Docket No. 50-344

SUBJECT: SPIRIT LAKE/TROJAN PLANT FLOODING SER

HYDROLOGIC ENGINEERING SAFETY EVALUATION REPORT
CONCERNING A POSTULATED BREAKOUT OF SPIRIT LAKE
AND ITS IMPACTS ON THE TROJAN PLANT

FIGURE 2
LOCATION OF SPIRIT LAKE OUTLET

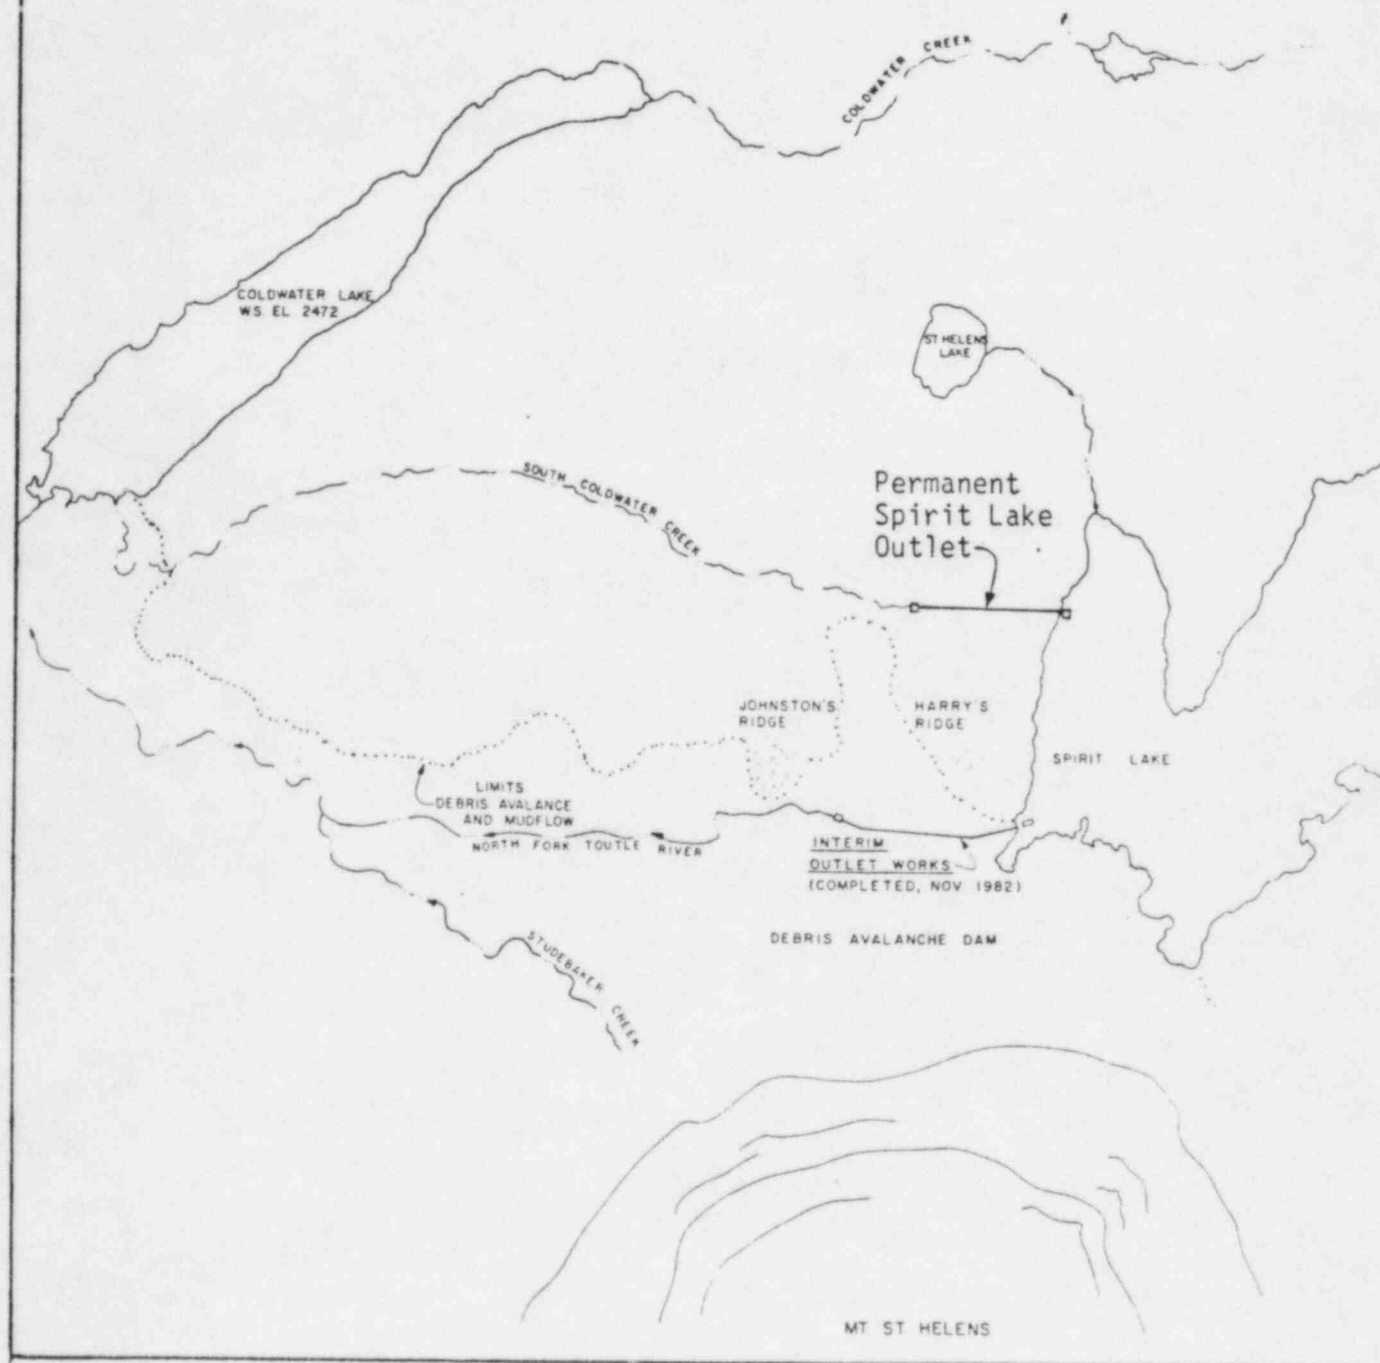
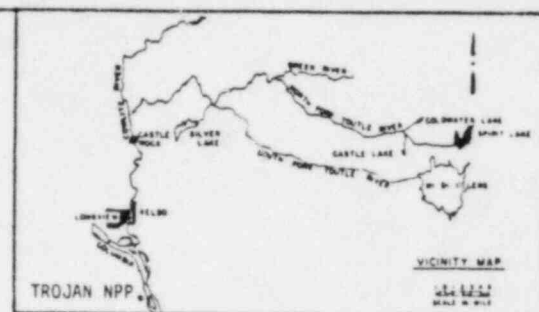
The tunnel being constructed between Spirit Lake and South Coldwater Creek (See Figure 2) will provide a permanent outlet for Spirit Lake. This tunnel will permanently lower the level of Spirit Lake and remove the threat of a breakout and the potential for high water in the Columbia River at the Trojan Plant.
